APPLICATION NO.	FILING DATE	FIRST NAMED INVENTOR	ATTORNEY DOCKET NO.	CONFIRMATION NO.	
10/662,888	09/15/2003	Jacques Billet	4384-000011 1167		
27572	7590 10/28/2004	•	EXAMINER		
HARNESS	, DICKEY & PIERCE	CHAN, KO HUNG			
P.O. BOX 828 BLOOMFIELD HILLS, MI 48303			ART UNIT	PAPER NUMBER	
	,		3632		
			DATE MAILED: 10/28/200	DATE MAILED: 10/28/2004

Application No.	Applicant(s)				
Office Action Summary		10/662,888	BILLET, JACQUES				
		Examiner	Art Unit				
		Korie H. Chan	3632				
The MAILING DATE of this Period for Reply	communication app	ears on the cover sheet with the c	orrespondence ad	dress			
A SHORTENED STATUTORY PERIOD FOR REPLY IS SET TO EXPIRE 3 MONTH(S) FROM THE MAILING DATE OF THIS COMMUNICATION. - Extensions of time may be available under the provisions of 37 CFR 1.136(a). In no event, however, may a reply be timely filed after SIX (6) MONTHS from the mailing date of this communication. - If the period for reply specified above is less than thirty (30) days, a reply within the statutory minimum of thirty (30) days will be considered timely. - If NO period for reply is specified above, the maximum statutory period will apply and will expire SIX (6) MONTHS from the mailin

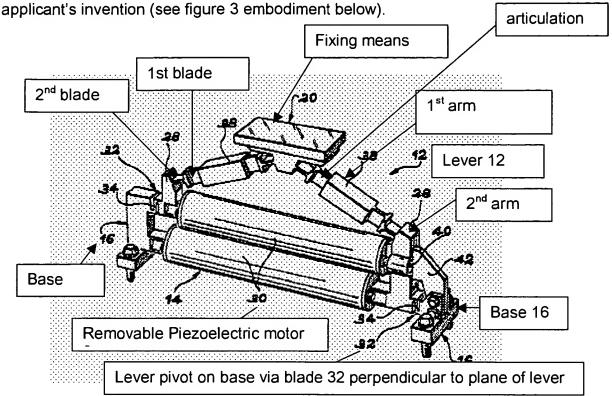
Claims 1-19 are rejected under 35 U.S.C. 102(b) as being anticipated by Bailly et al (French patent no. FR 2,773,890). Bailly et al disclosed all the claimed features of applicant's invention (see figure 3 embodiment below).

Also, Bailly discloses three devices (fig. 1) spaced 120 degrees apart (page 10, line 12)
